ZONING CHANGE REVIEW SHEET

CASE: C814-89-0003.02 – 305 S. Congress PUD DISTRICT: 9

TO: PUD-NP, to change conditions of zoning

ADDRESS: 305 S. Congress Avenue

STREET SECTION B-B'
BARTON SPRINGS AVENUE TYPICAL SECTION 58' WIDE

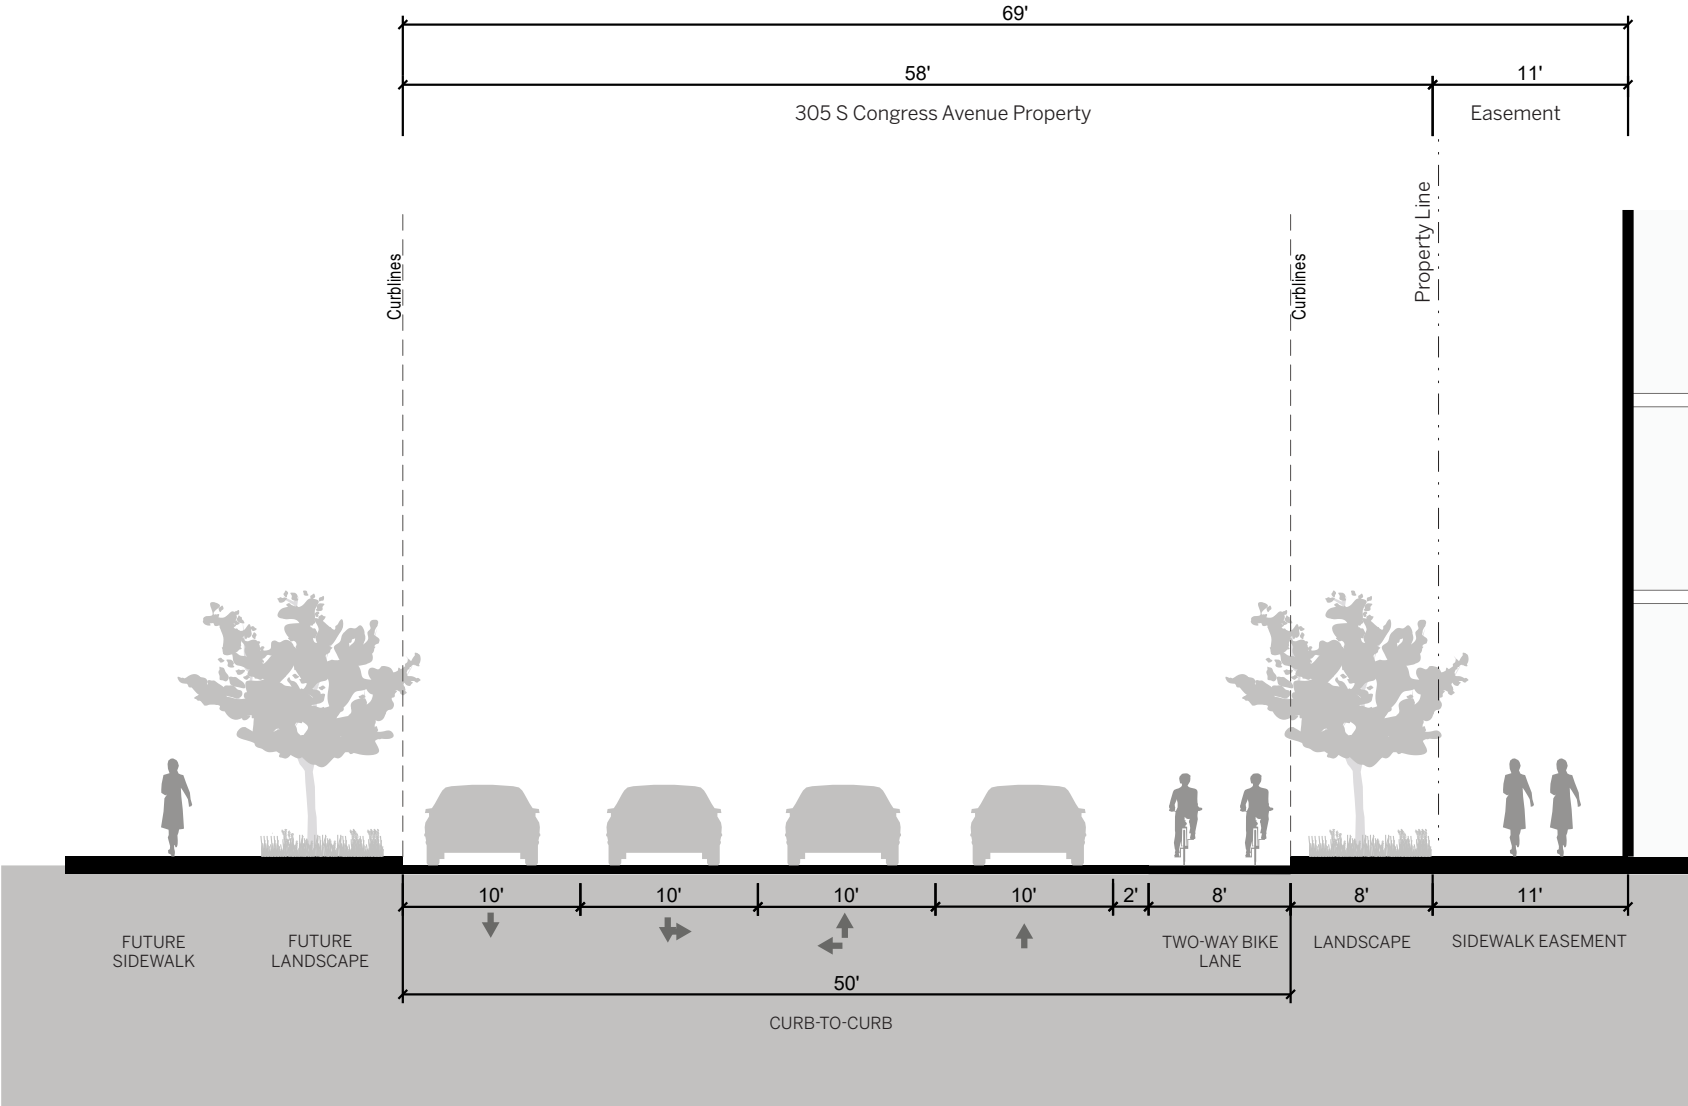
- Barton Springs Road extension shall be considered an Urban Roadway for the purposes of complying with Chapter 25-2, Subchapter E – Design Standards and Mixed Use, and will be designed in accordance with the PUD street sections located on Sheet 4.

31. Barton Springs Road extension shall be considered an Urban Roadway for purposes of complying with Chapter 25-2, Subchapter E – Design Standards and Mixed Use, and will be designed in accordance with the PUD street sections located on Sheet 4.

PEDESTRIAN WALKWAY TYPICAL SECTION E-E' 45' WIDE

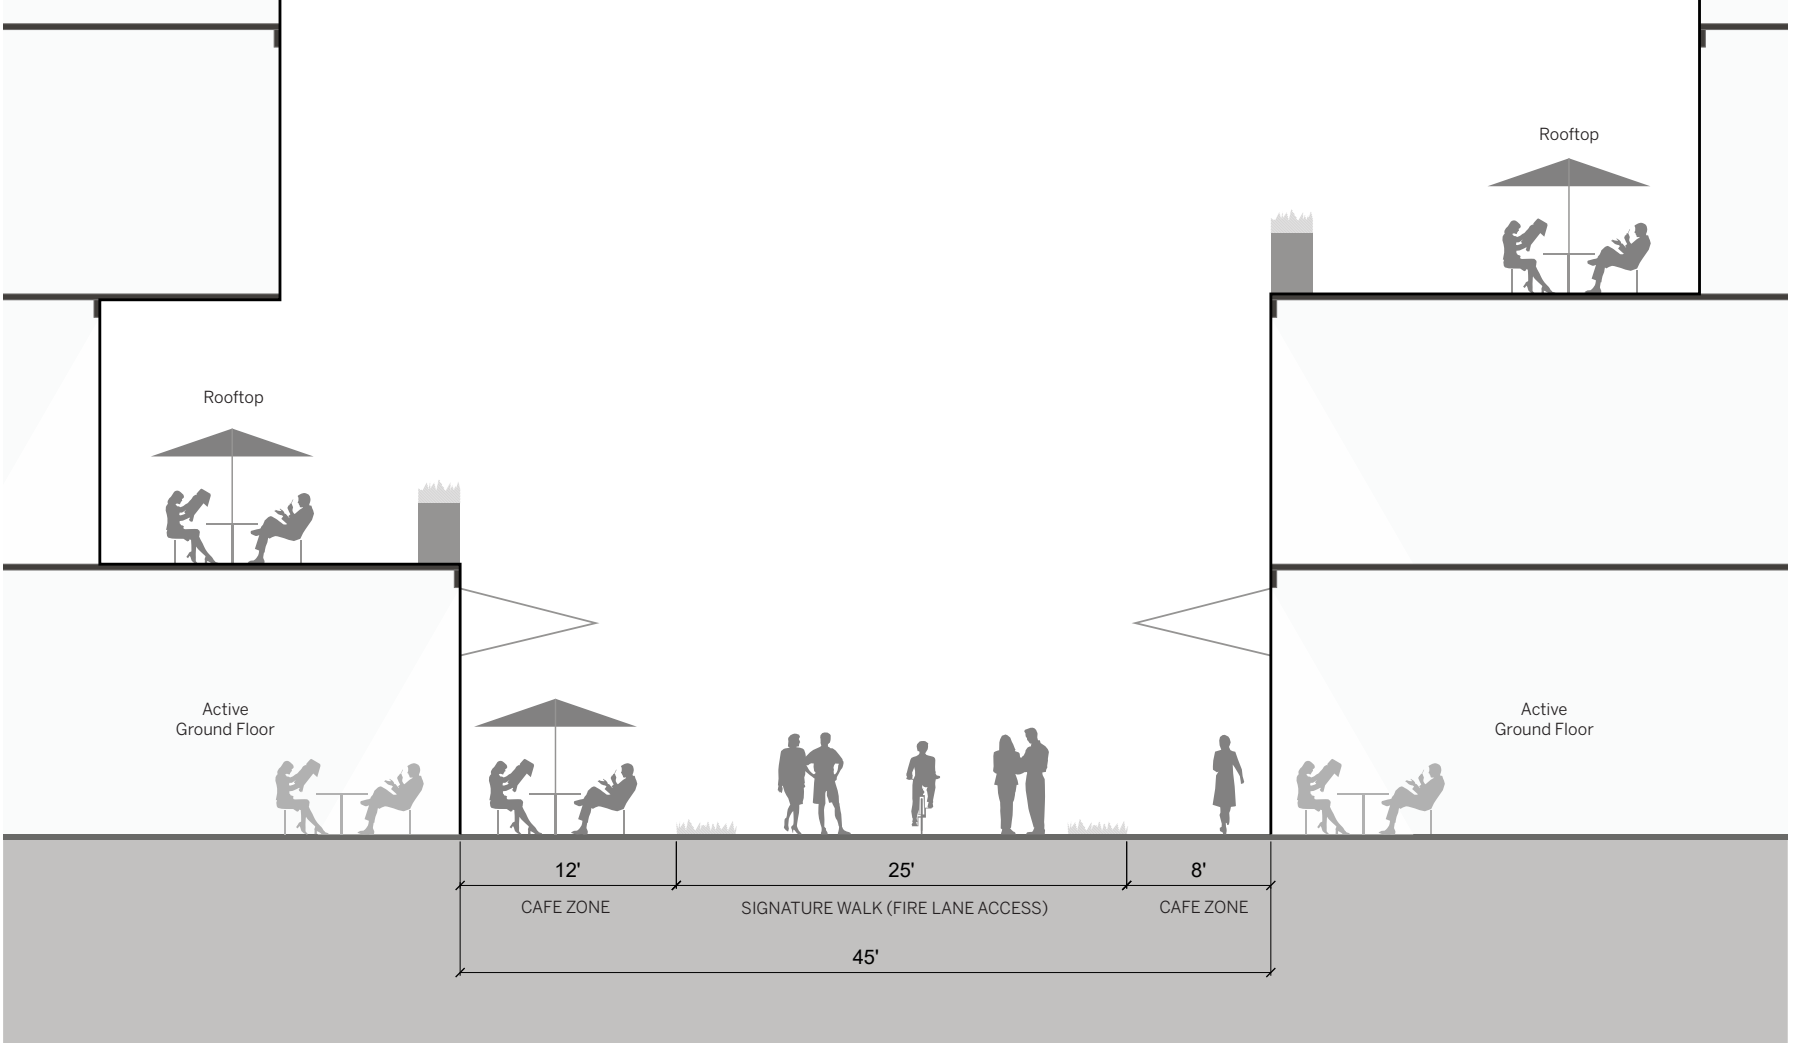
51. Bollards, or another similar type of barrier, will be used to close the Pedestrian Walkway, shown on Sheet 4 as Section E-E, from vehicular traffic.

WG Amendment #14

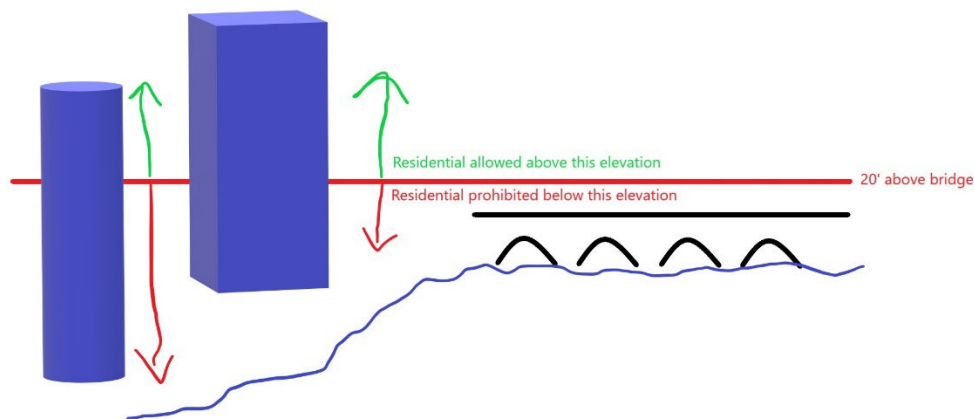
- 5) Please provide a schematic to explain this setback amendment. It is difficult to visualize the phrase “below 20’ above the elevation of the Congress Ave. bridge pavement.”
